TGn Sync Response to Questions

Date: **2005-03-16**

Benefits of TGn
Sync Extended
MCS set (from
presentation)

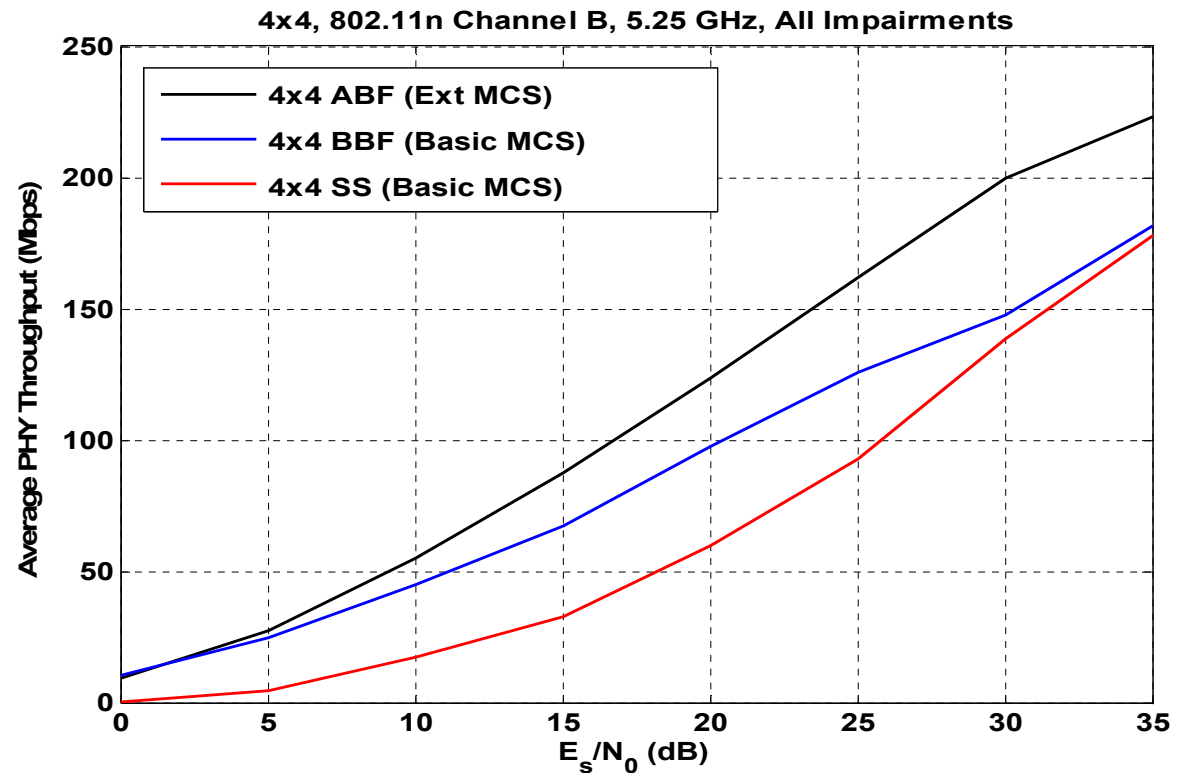
In ABF, instead of having, for example, {256-QAM, 256-QAM, 256-QAM, QPSK}, why not just use 3 spatial streams if the streams are that different in quality?

2x1 Tx Bf vs 2x1 STBC, Ch. B, 5.25 GHz, No Imps., Perf. Ch. Est.

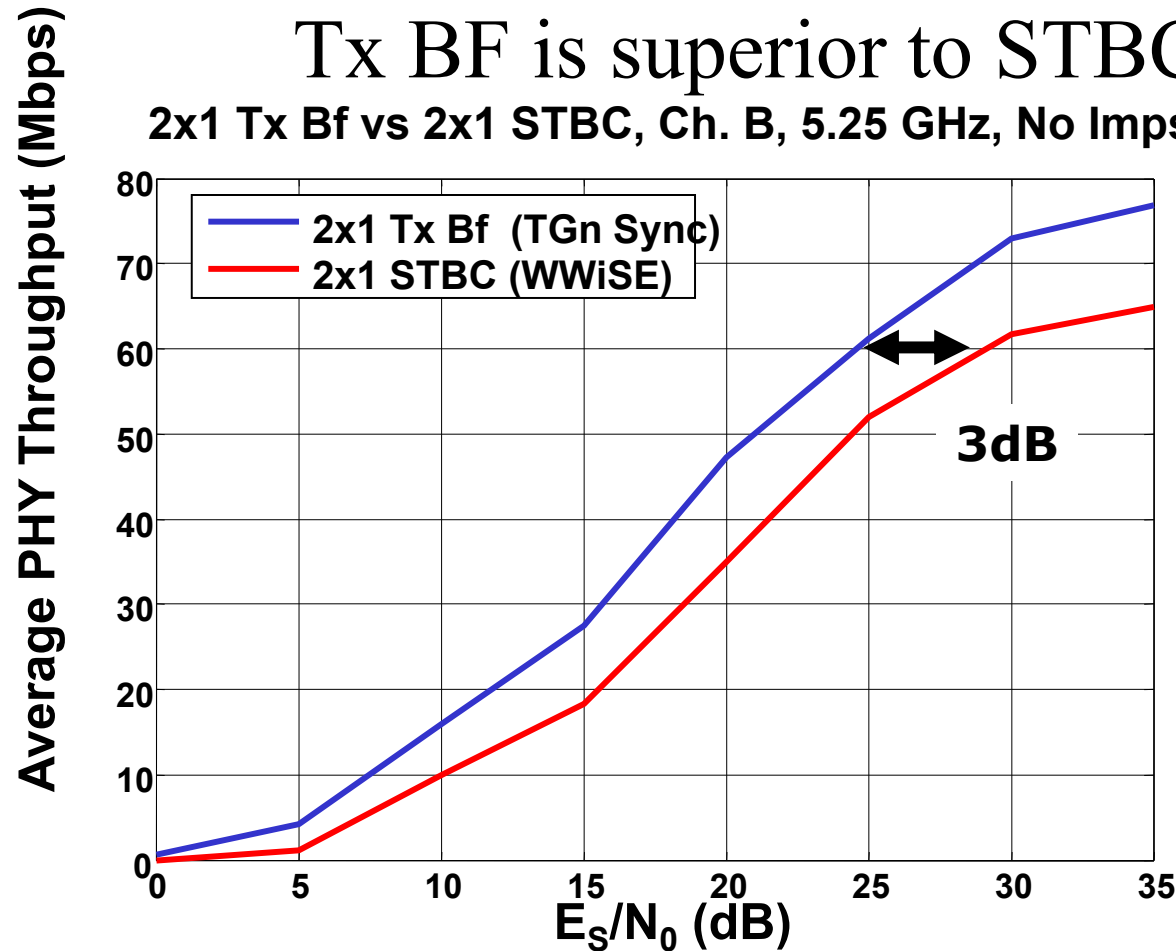
Why are space-time block codes missing from the proposal?

- Is there any technical reason why these have been omitted?
- Simplicity, not needed since TxBf outperforms it. Additional complexity of 2-symbol processing, overhead of extra dead symbol etc.

Tx BF is superior to STBC

➔ Also complexity of dual symbol processing, more modes etc.
